DC179

Title	Change of Arm set, Joint, Hose connector, Dust nozzle Elimination of O ring 20, O ring 23 Addition of Rivet 7
Model	DSL800, XLS01
Country	All countries
Description	To improve the dust collecting efficiency; • Arm set, Joint, Hose connector and Dust nozzle will be changed. • O ring 20 and O ring 23 will be eliminated. • Rivet 7 will be added.

[1] Arm set (183L76-5)

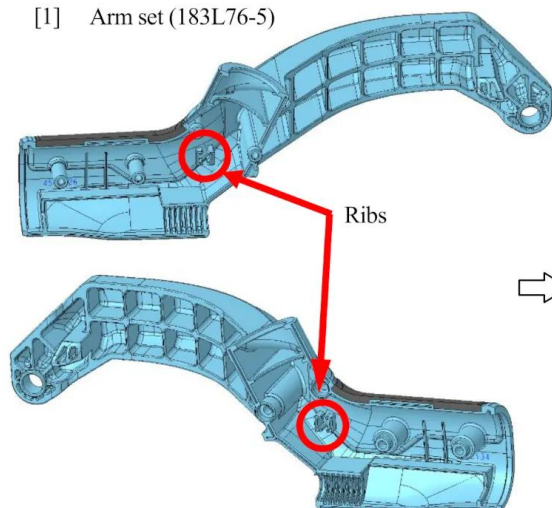
Arm set (183T15-3)

[2] Joint (459222-3)

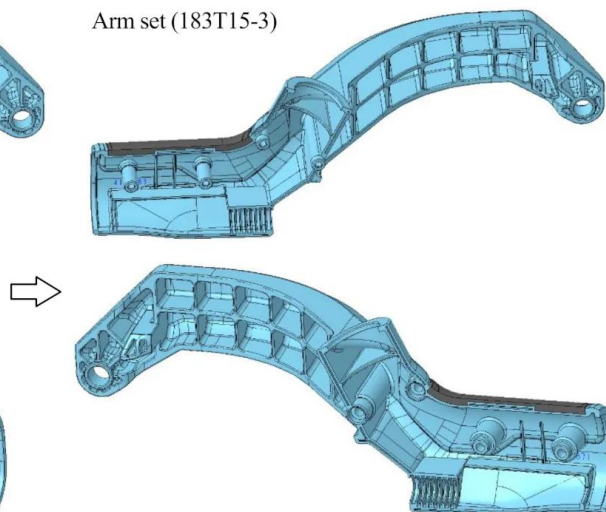
Joint (422617-3)

- [4] Elimination of O ring 20 attached to the current Joint
- [5] Elimination of O ring 23 attached to the current Joint

[6] Dust nozzle (459234-6)

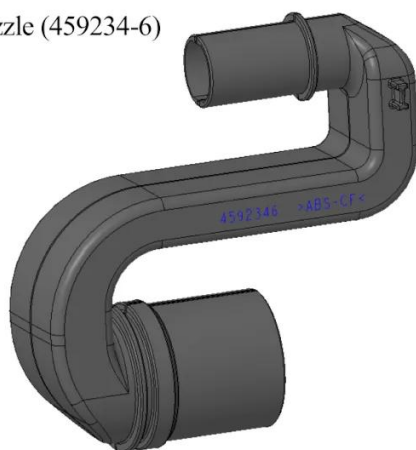
Dust nozzle assy (127672-7)

[7] Addition of Rivet 7 (412987-8)

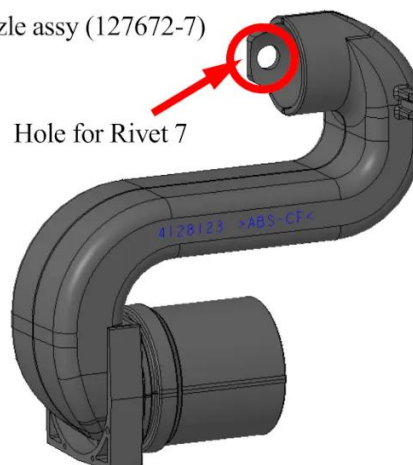
Insert Pipe B complete into Dust nozzle assy, then fasten them with Rivet 7 (412987-8).
